Date: 30/01/2023
RE: LINK-NP3 & LINK-NP5 Usage with A2 & A3 Modules
Products affected: Configurations using OP A2 and/or OP A3 Modules connected in parallel.

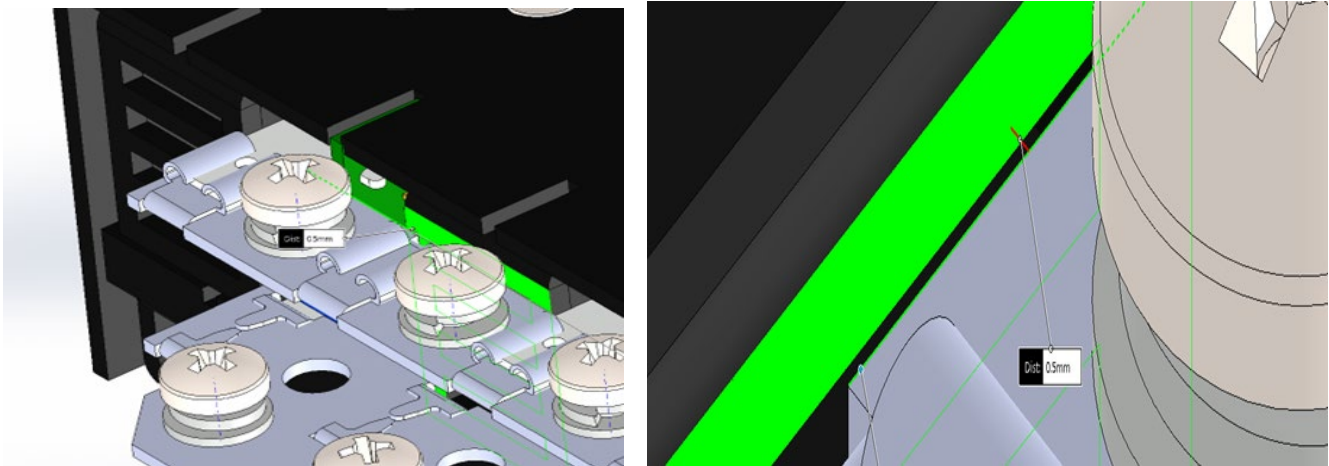
It can be seen from the below images that the existing parallel links (Link-NP3 & Link-NP5) come within 0.5mm of the OP A2 or OP A3 heatsinks when fitted in two or three module parallel configurations.

The Link-NP3 and/or Link-NP5 should not be used to parallel connect the 300W dual slot OP A2 or OP A3 modules due to risk of shorting to the module heatsink/configuration chassis. Vox Power will design and release two new parallel links for exclusive use with the 300W OP A2 & A3 modules imminently and will circulate an updated accessory datasheet showing the new links and part numbers.

Any existing or pending customers who use or intend to use the existing Link-NP3 or Link-NP5 accessories should contact Vox Power for further details and corrective actions.
